# HISTORIC AND DESIGN REVIEW COMMISSION

March 17, 2021

**HDRC CASE NO:** 2021-100  
**ADDRESS:** 415 MISSION ST  
**LEGAL DESCRIPTION:** NCB 946 BLK 2 LOT 22  
**ZONING:** RM-4 H HS  
**CITY COUNCIL DIST.:** 1  
**DISTRICT:** King William Historic District  
**LANDMARK:** Individual Landmark  
**APPLICANT:** Fernando De Leon/One Stop Code Consulting  
**OWNER:** Jake Jazdzewski/JAZDZEWSKI JAKE & MONICA  
**TYPE OF WORK:** Relocation and exterior modifications to rear accessory structure  
**APPLICATION RECEIVED:** February 22, 2021  
**60-DAY REVIEW:** Not applicable due to City Council Emergency Orders  
**CASE MANAGER:** Stephanie Phillips  
**REQUEST:**

The applicant is requesting conceptual approval to:

drawing title:  
**DEMO PLANS**

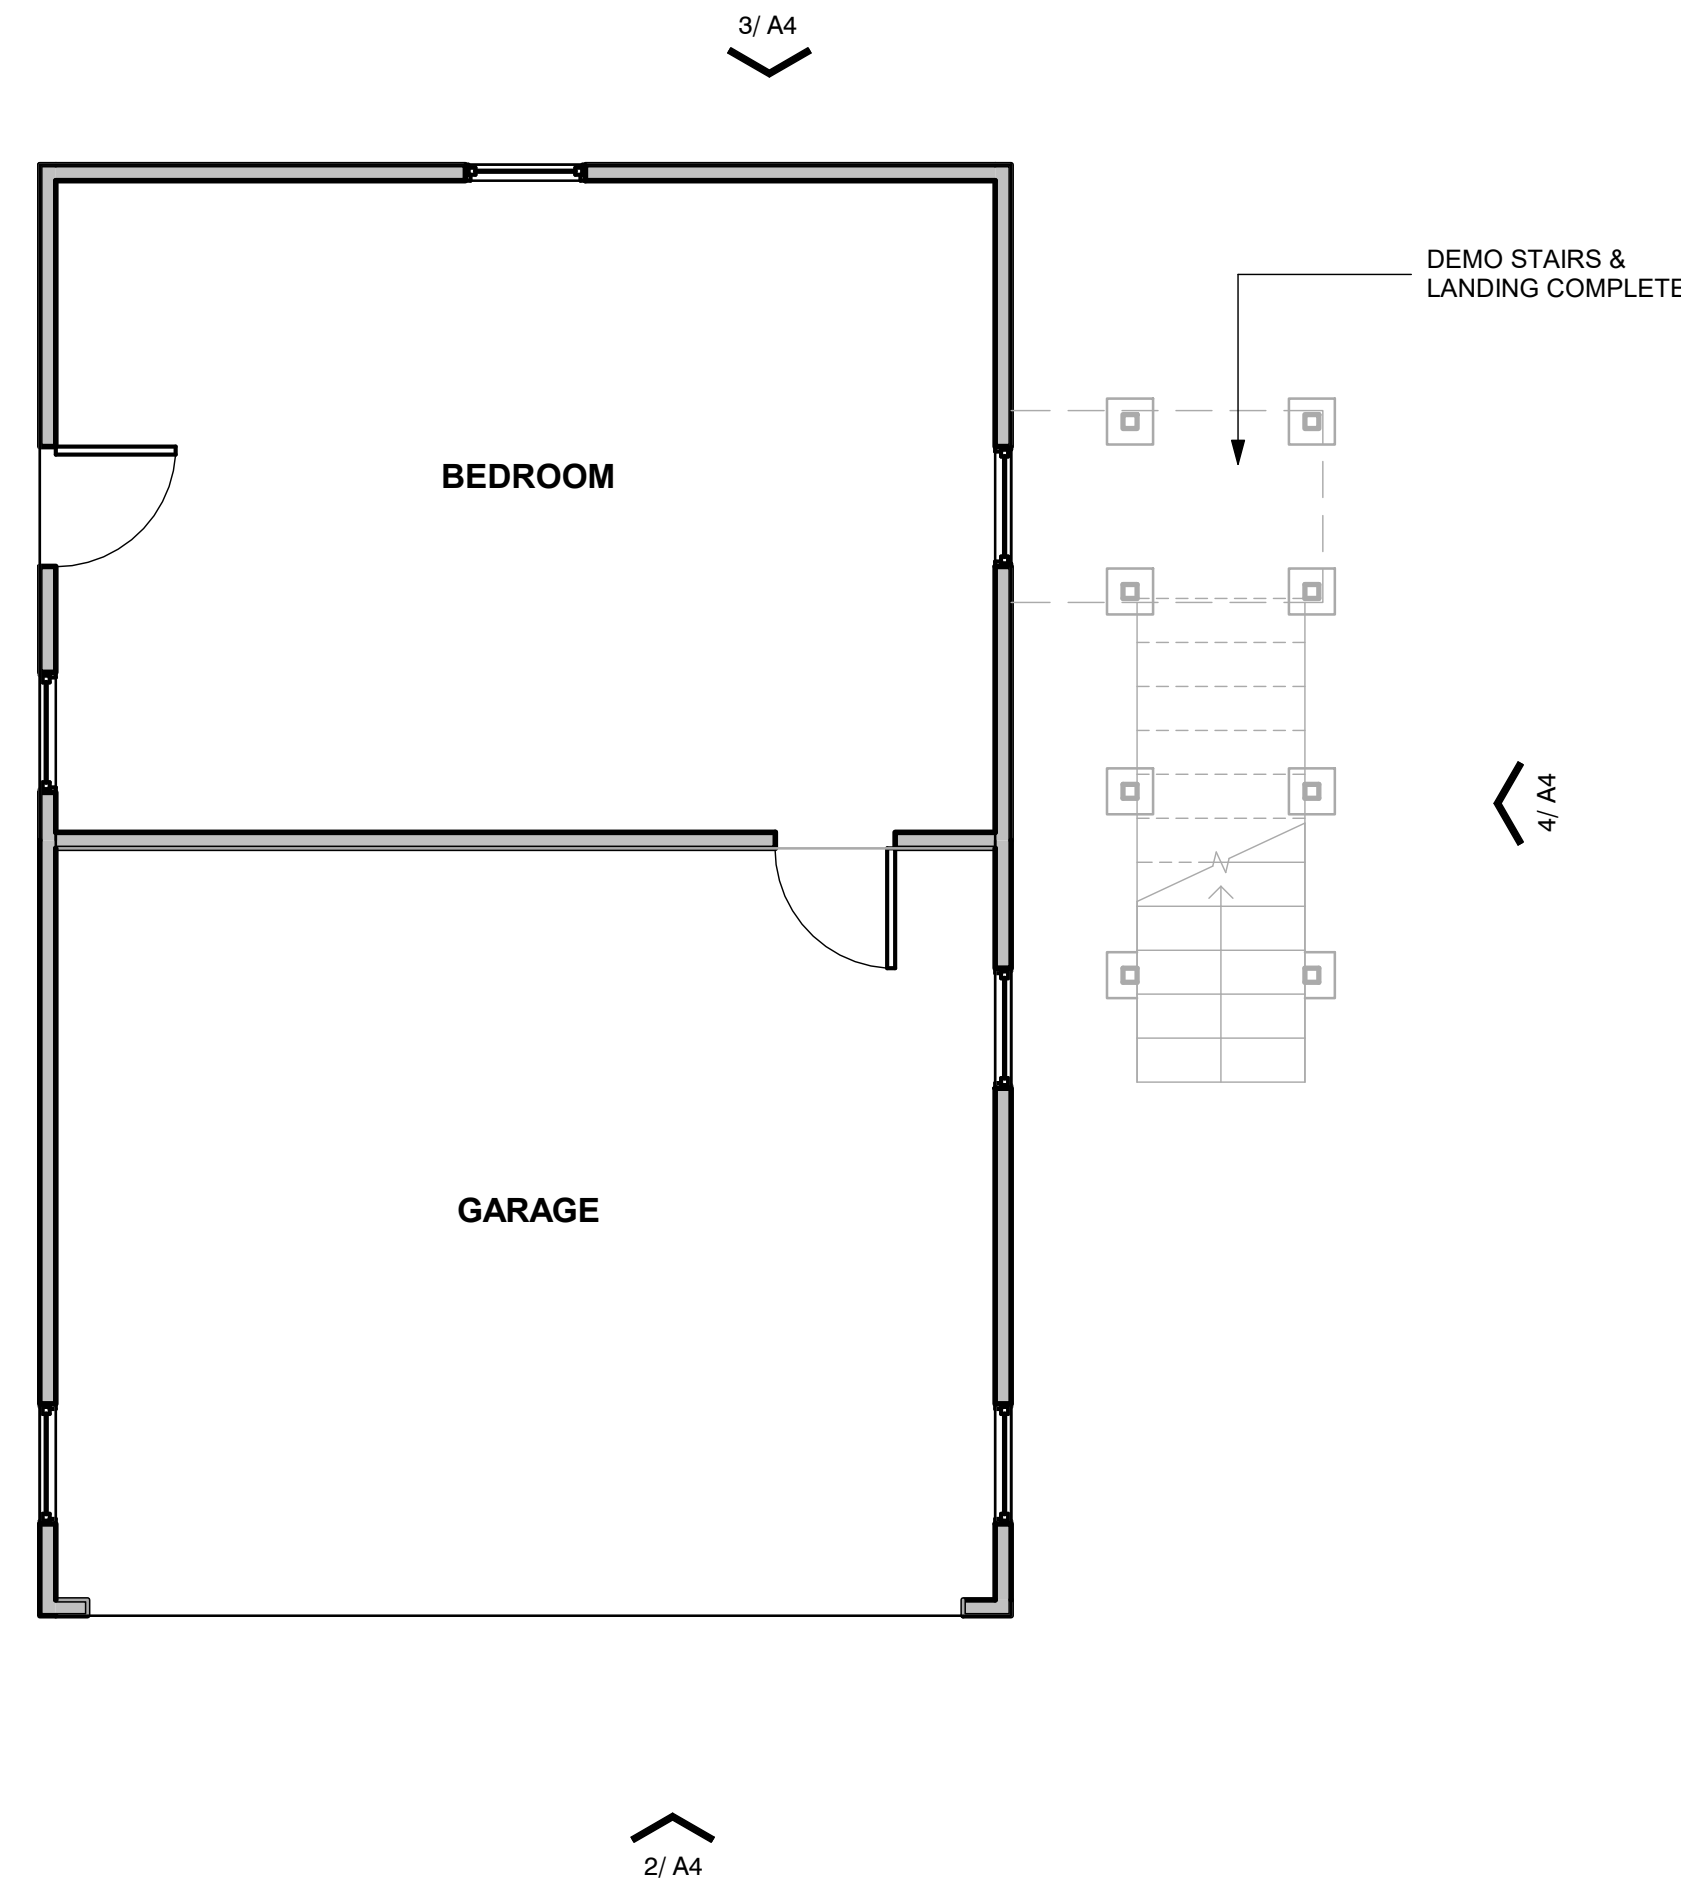
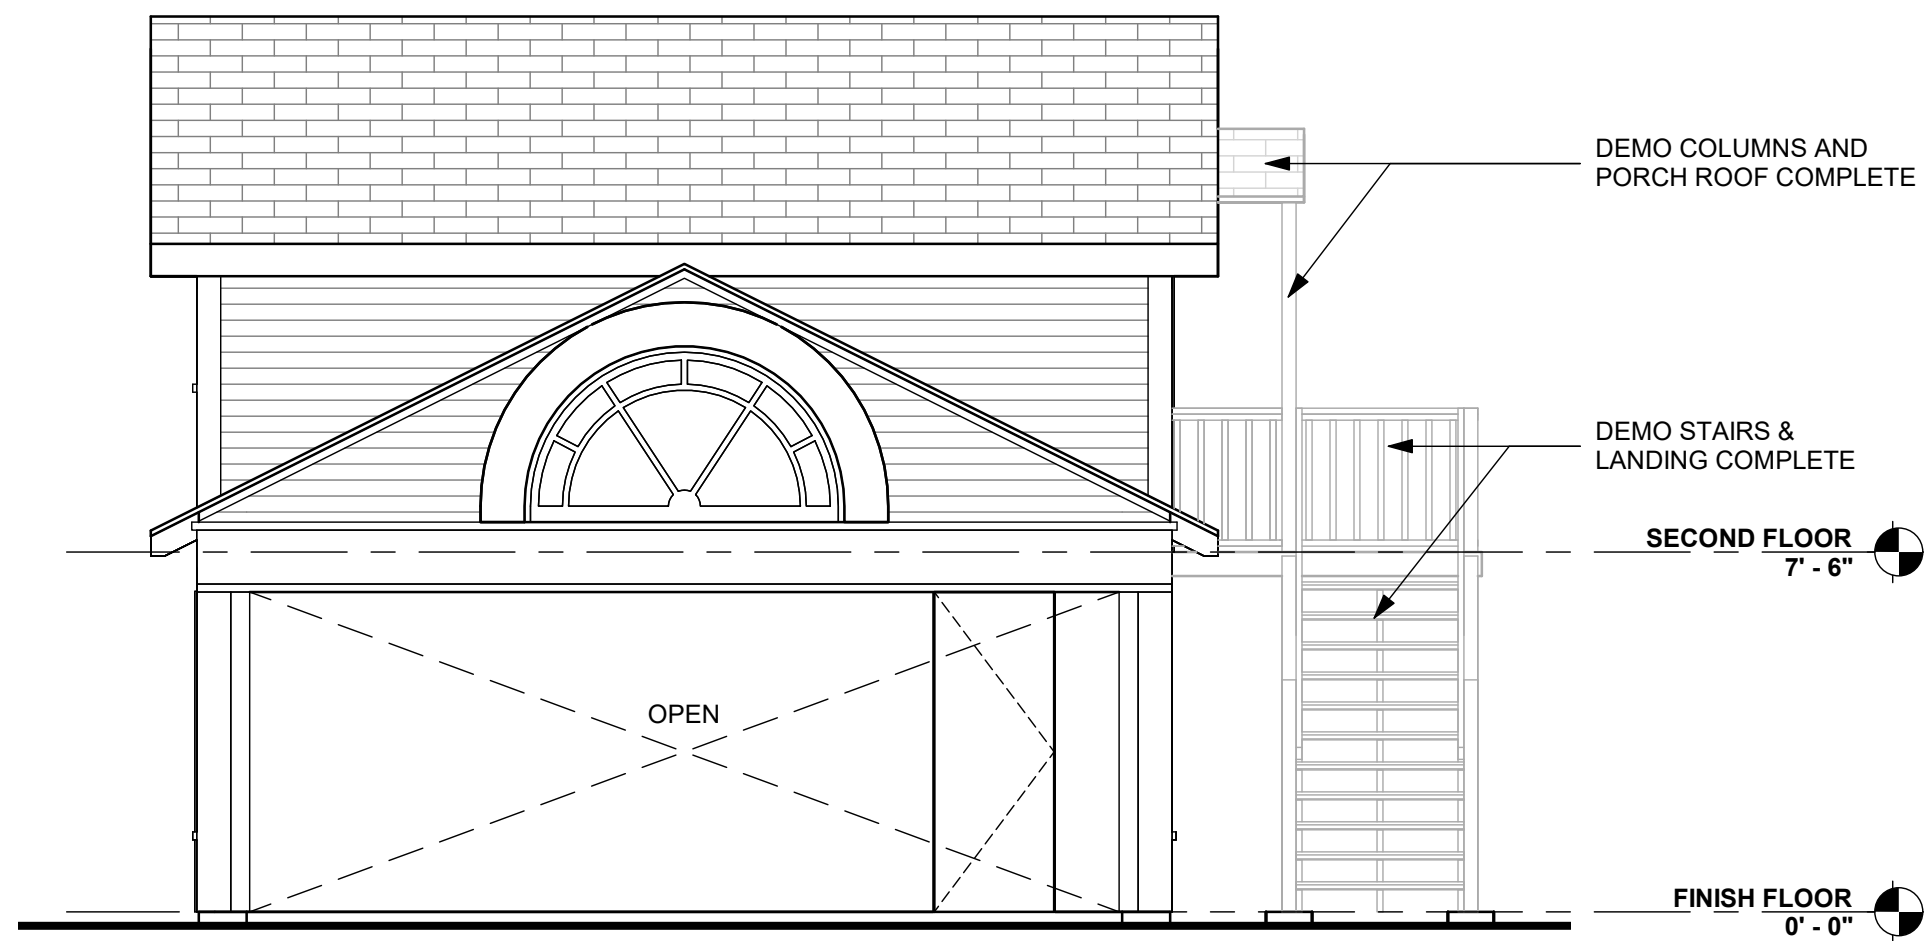
- d. **STAIR REMOVAL** – The applicant has proposed to remove an existing outdoor stair leading to the second story. The applicant has proposed to incorporate an interior staircase to address access and egress. Staff finds the stair removal acceptable.

- e. **FENESTRATION MODIFICATIONS** – The applicant has proposed to replace an existing second story door at the stair landing with a new window to match existing in terms of scale, proportion, configuration, and inset. The awning above the door will also be removed. Staff generally finds the request appropriate, but finds that the door should be retained and reused elsewhere on the structure, or stored on the property. Additionally, the applicant has proposed to remove an existing first floor window and enclose with siding on the back elevation. An existing second story window on this elevation will be retained. Staff generally finds the request acceptable based on its limited visibility from the public right-of-way and the retention of an additional opening, but finds that the window should be retained and reused elsewhere on the structure, or stored on the property. Staff also finds the addition of new sliding doors on an ancillary elevation to be appropriate.

- i. That the applicant retains the existing windows and doors to be removed and reuses them in other openings on the structure, to include the replacement of windows deteriorated beyond repair if applicable, or keeps them onsite for future use as noted in findings e and f.
